DEVELOPMENT REVIEW BOARD REPORT

Storage at McDowell 46-DR-2019	Request by owner for approval of a site plan, landscape plan, and building elevations for a new storage facility development on a +/- 1.36 -acre site with Highway Commercial (C-3) zoning, located at 7025 E. McDowell Rd.
---	---

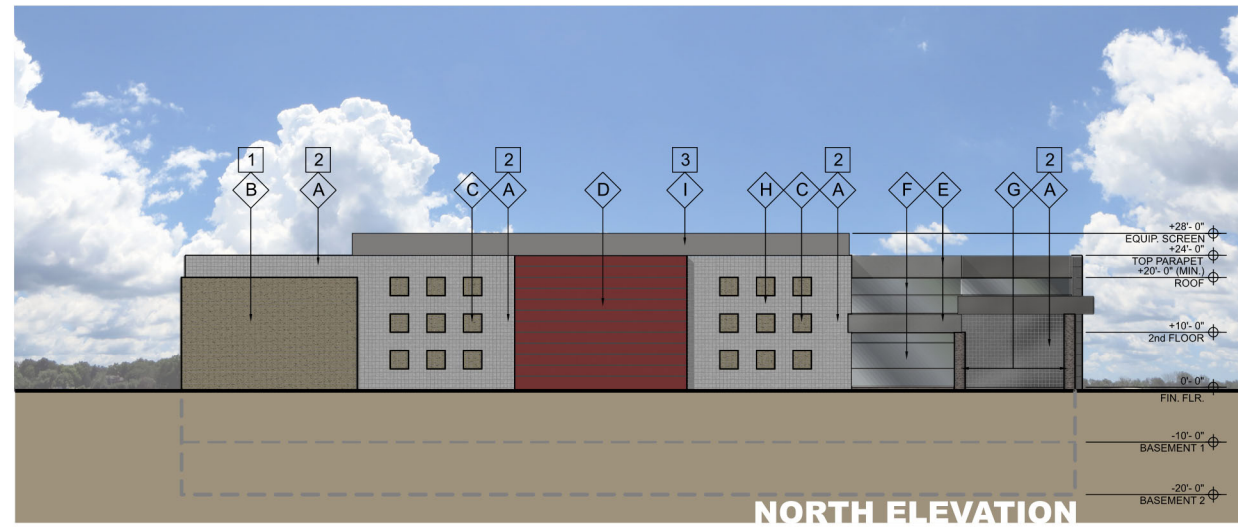
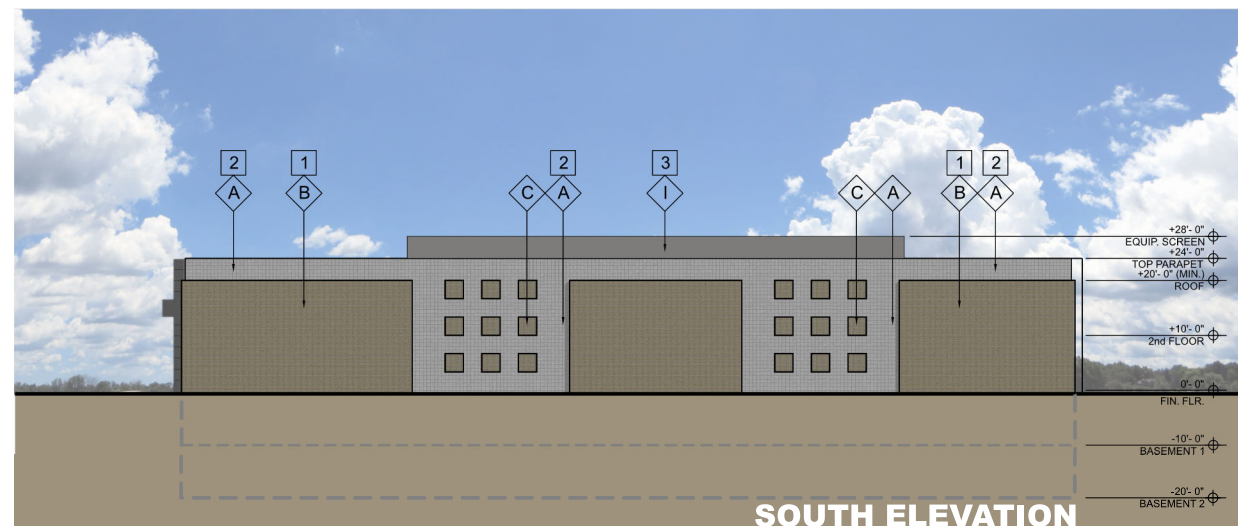
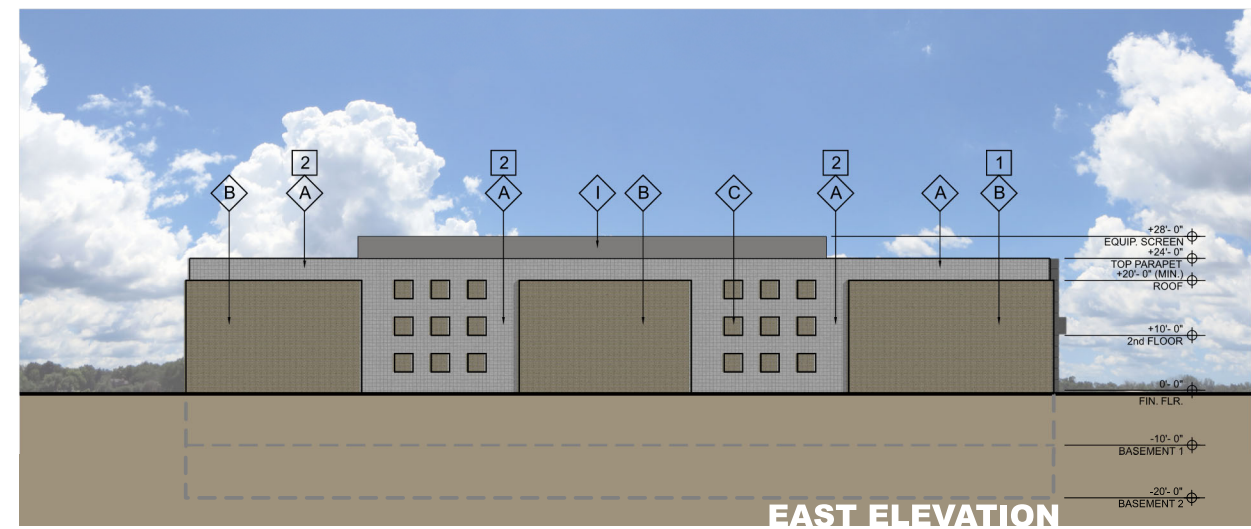
Elevations:

- Break up the building massing of the proposed storage building due to its large size
- Provide meaningful undulations and projections to help vary the building plane
- Elevations should utilize a variety of materials for an attractive composition
- Include horizontal elements to help add visual interest
- Add windows to the building elevations (but they should be tinted and not used for storage display)
- Avoid a bulky or boxy appearance
- The subject site's location on McDowell Road warrants special attention to design

The applicant has incorporated varied building massing through the addition of 8” to 22” deep red perforated metal panels with associated gray concrete columns located along the east, north, and west elevation. In addition, a gray metal canopy has been added over the new lobby location for a shaded entrance into the building. There have also been more windows added to the north elevation on a pedestrian friendly level. Finally, the split face and scored concrete masonry units locations along the façade were revised to add horizontal interest.

PRELIMINARY SITE PLAN

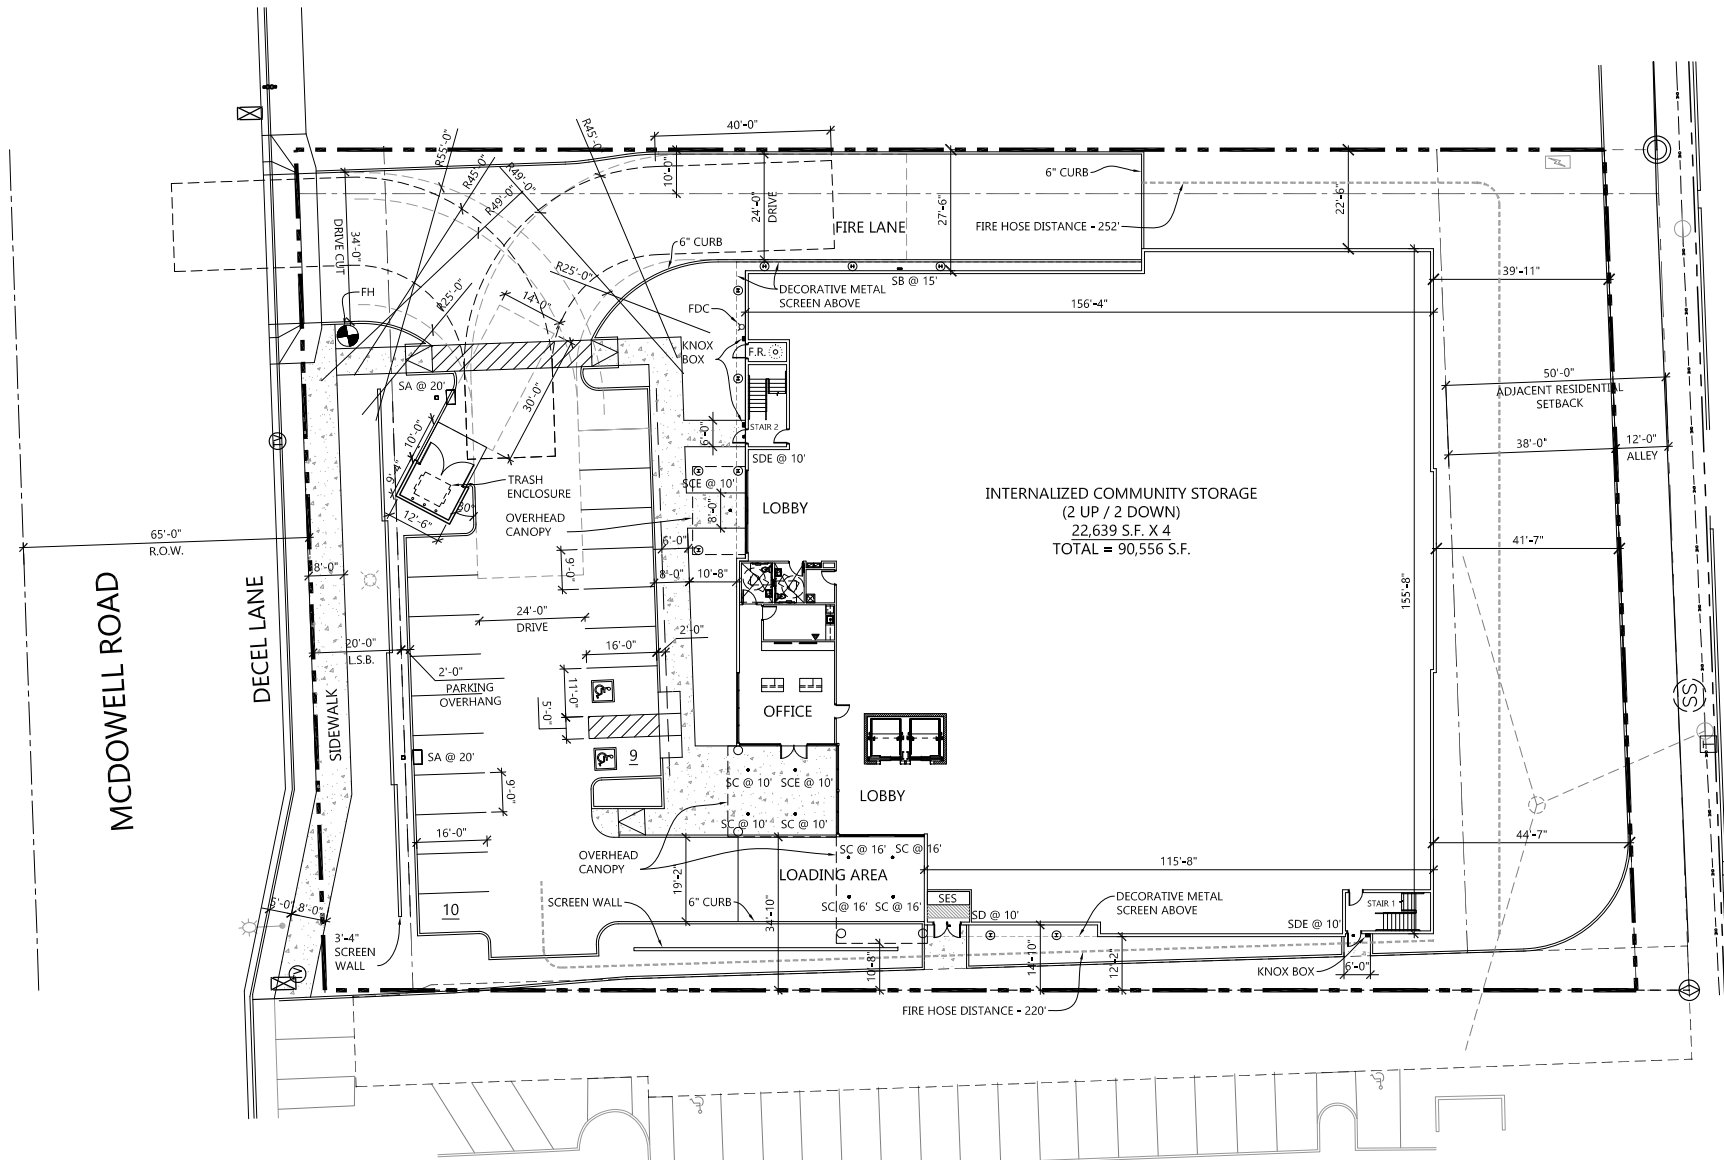
- *Revisions were made to the vehicular driveway location, fire lane access, and refuse pick up from the past submittal to address concerns raised by the DRB. Due to the size of the building, the previous site plan’s fire lane and refuse access was located along the west side of the building and east portion of the neighbor’s property, which required cross access agreement to be in place.*

The applicant was not able to obtain a cross access agreement from the neighbor, which resulted in relocating the fire lane, refuse, and driveway to the east side of the site. The new driveway location conflicted with the proposed entrance into the Papago Plaza deceleration lane. Per the Transportation department, the applicant is now responsible to revise the deceleration lane to extend across the project’s frontage to avoid conflicts. The applicant has agreed to this stipulation and it is shown on the site plan. The Fire and Solid Waste department have approved the site plan revisions.

LANDSCAPE PLAN

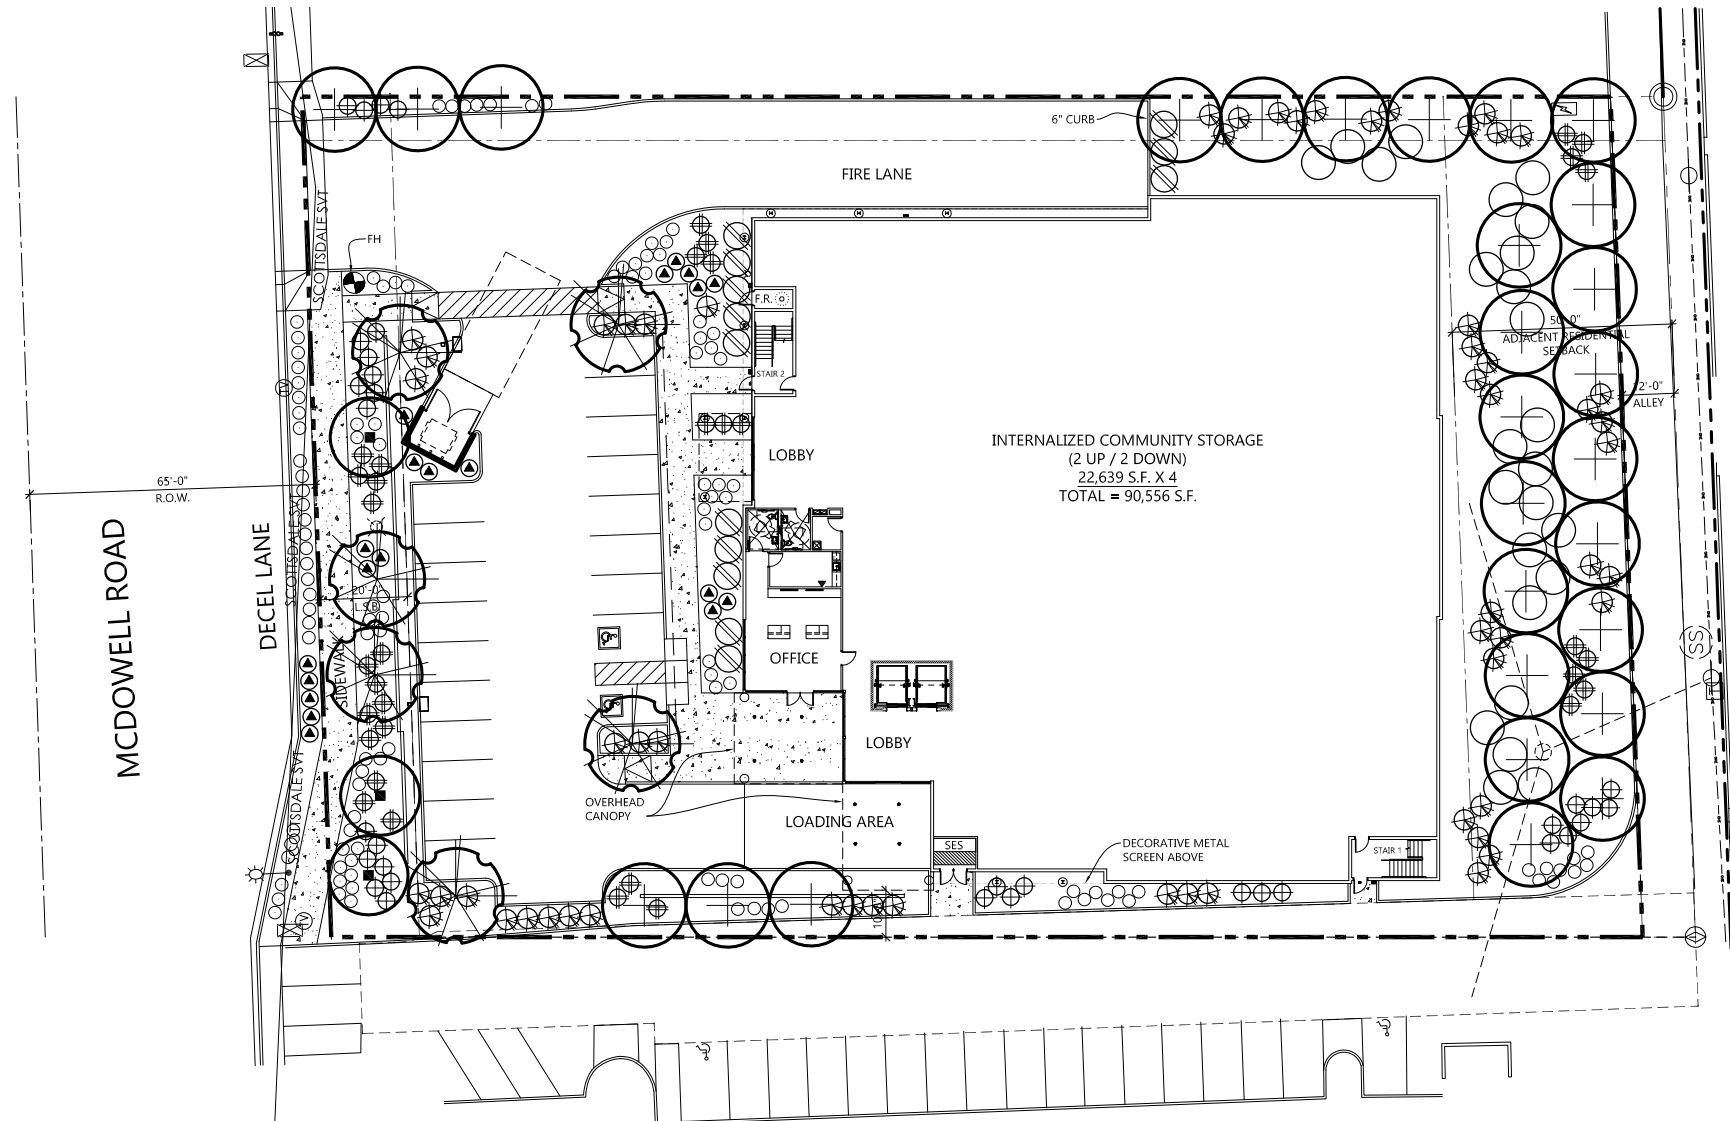
Landscape Plan:

- Provide intentional and purposeful planting arrangements that compliment and relate to the building architecture
- Site plan and landscape plan coordination needs to occur to show correct sidewalk locations
- Landscape plan needs to represent actual tree and plant sizes correctly
- Trees in the area between the street and public sidewalk are placed too close together and the spacing is not representative of their mature size
- Proposal feels scattered, try to incorporate more uniformity as the apartments have done next door

Regarding landscaping, the applicant worked with a landscape architect to revise tree and plant locations to be more thoughtful and intentional in relation to the architecture, as well as correcting the sizes and proportions on the plan.

- C. If any native plants are to be disturbed with the proposed construction, the applicant shall submit a native plant application and native plant inventory produced by an approved salvage company.
- D. With final plans, the landscape plan shall be updated so that no more than 7 feet is without plant or tree coverage.

DRAWING TITLE
COLOR - BUILDING
ELEVATIONS

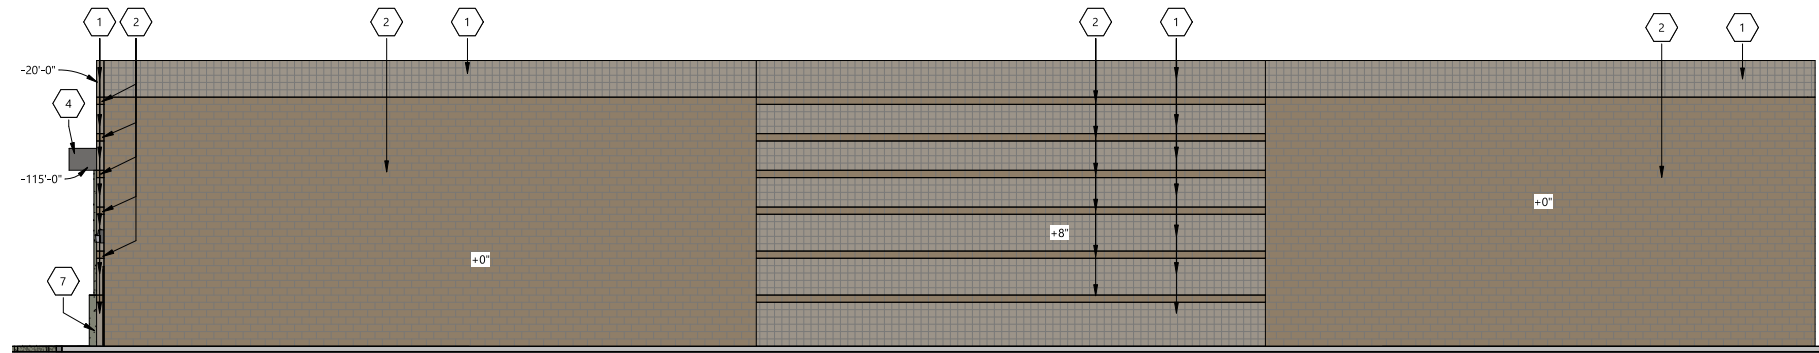
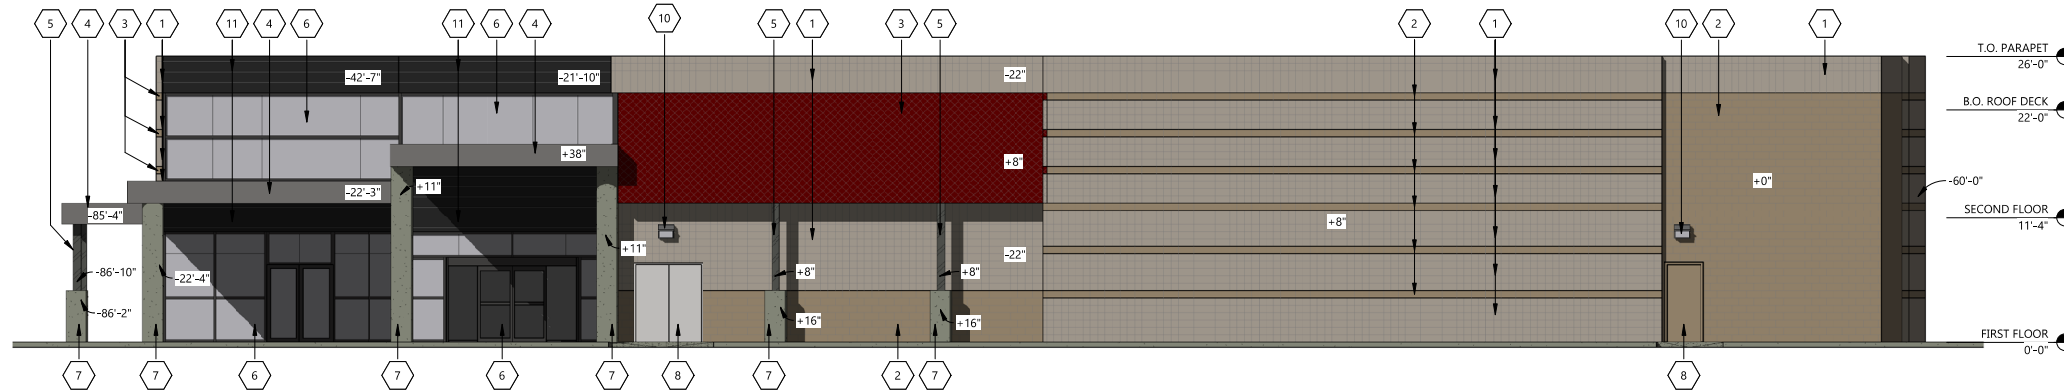
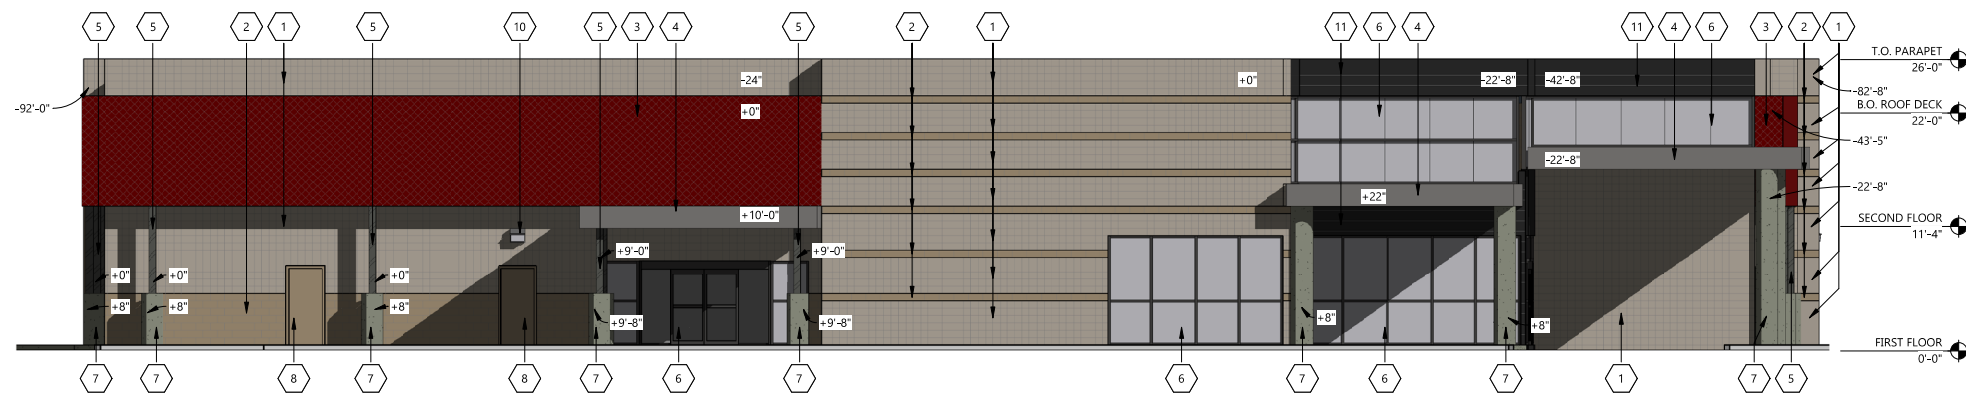
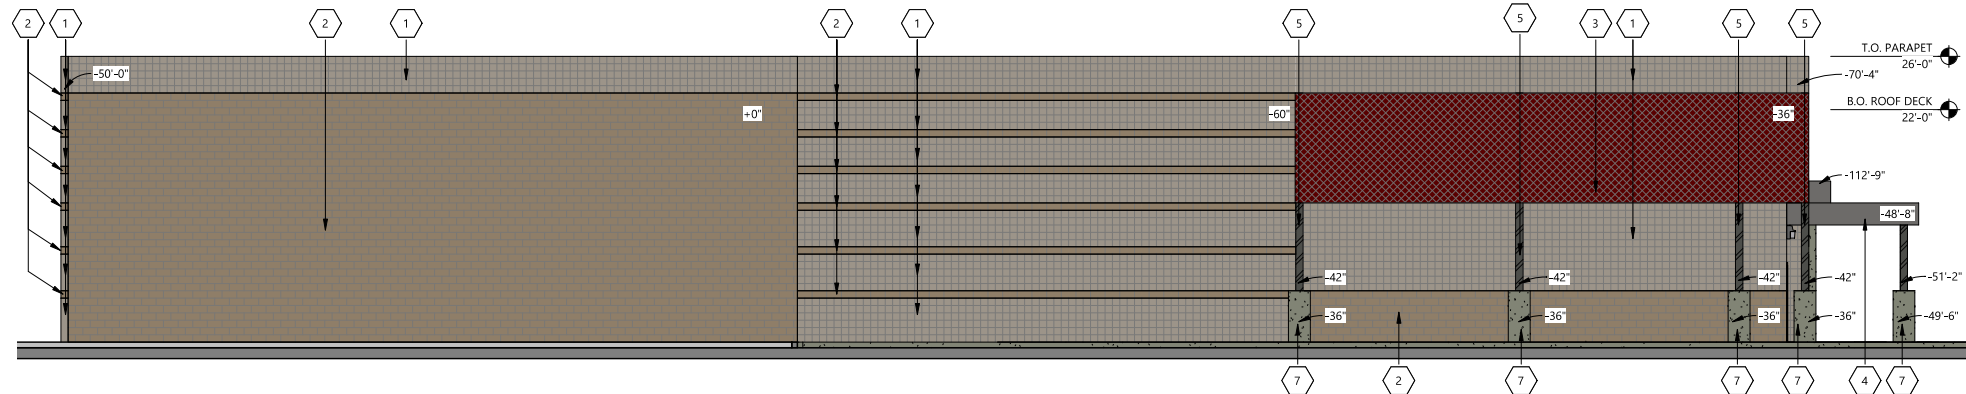
- *Staff finds that the applicant has worked to revise the previous architectural design and landscaping in response to the past DRB hearing concerns.*
